**Comanche Peak Nuclear Power Plant, Units 3 & 4
COL Application**

**Part 3,
Environmental Report
Update Tracking Report**

Revision 5

Figure 3.1-1 Site Plan

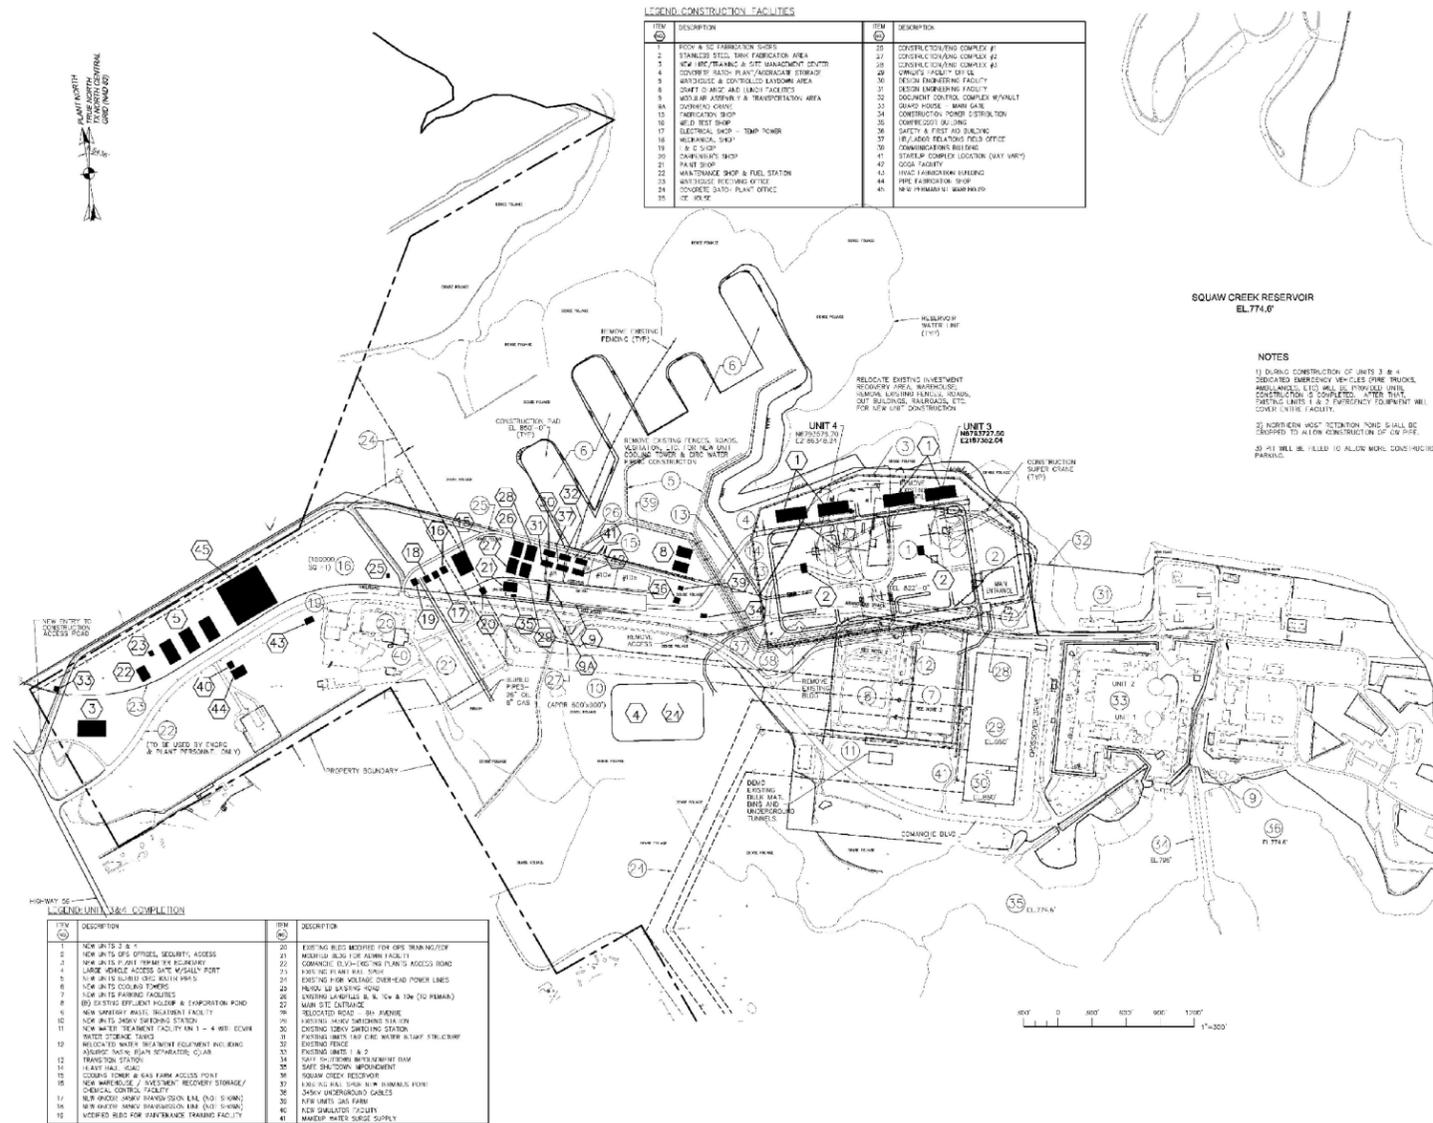
CTS-00842

Figure 3.4-3 Intake and Discharge Locations (Sheet 3 of 3)

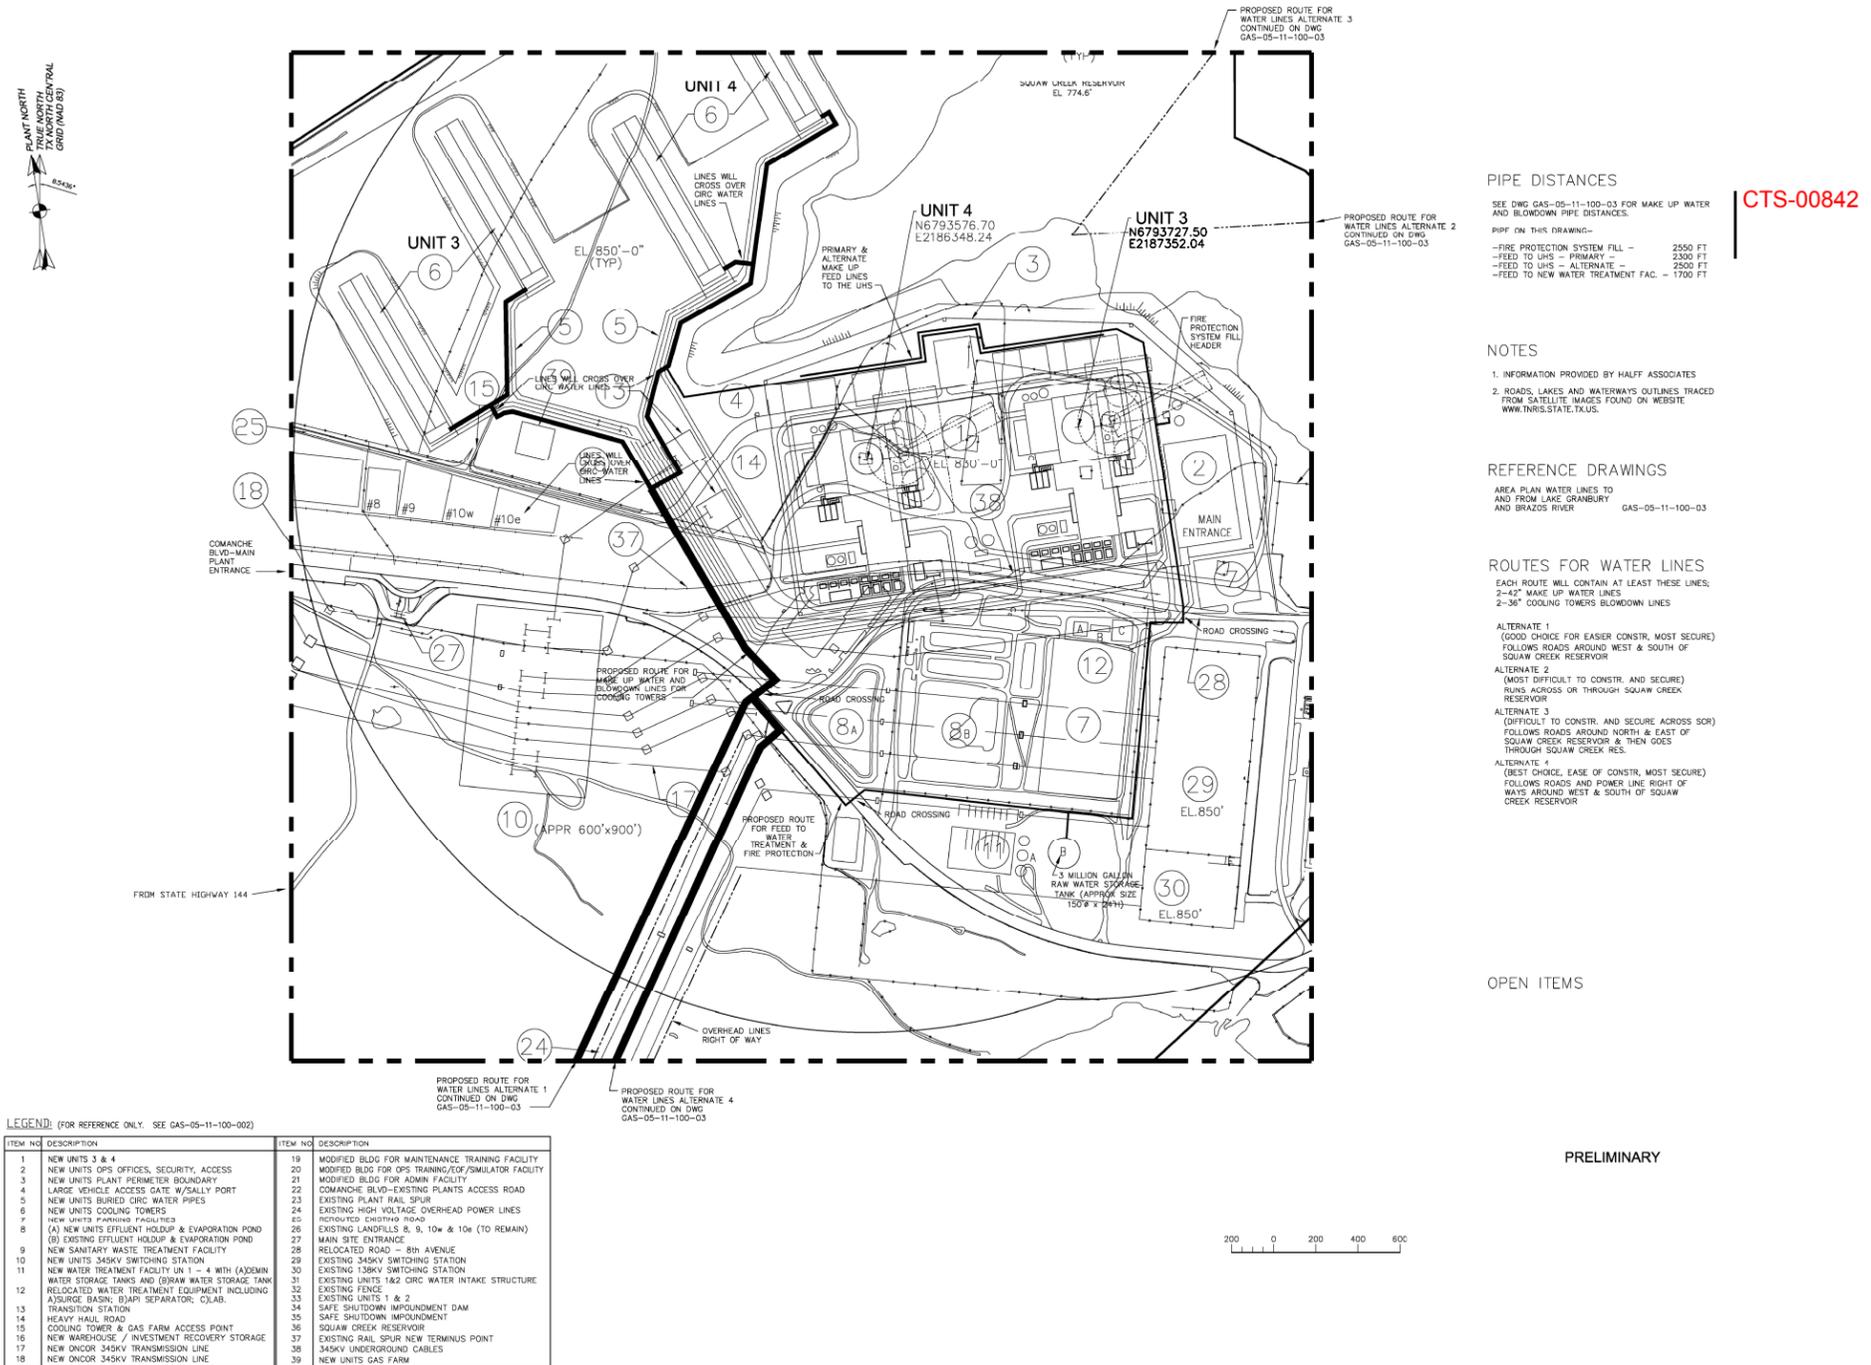
Change ID No.	Section	ER Rev. 0 Page	Reason for change	Change Summary	Rev. of ER T/R
			Granbury, with MHI confirmed flow rates used in FSAR.	to be consistent with the circulating water system description.	
CTS-00465	3.6.1.1	3.6-2	Reconcile ER circulating water system, makeup water, and blowdown from Lake Granbury, with MHI confirmed flow rates used in FSAR.	Revised the water rates from 13,038 gallons per minute to 13,050 gallons per minute, to be consistent with the circulating water system description.	4
CTS-00842	Figure 3.1-1	--	Erratum	Revised the coordinate of the center of the reactor of CPNPP unit 3.	5
CTS-00842	Figure 3.1-2	--	Erratum	Revised the coordinate of the center of the reactor of CPNPP unit 3.	5
CTS-00842	Figure 3.4-3	--	Erratum	Revised the coordinate of the center of the reactor of CPNPP unit 3.	5
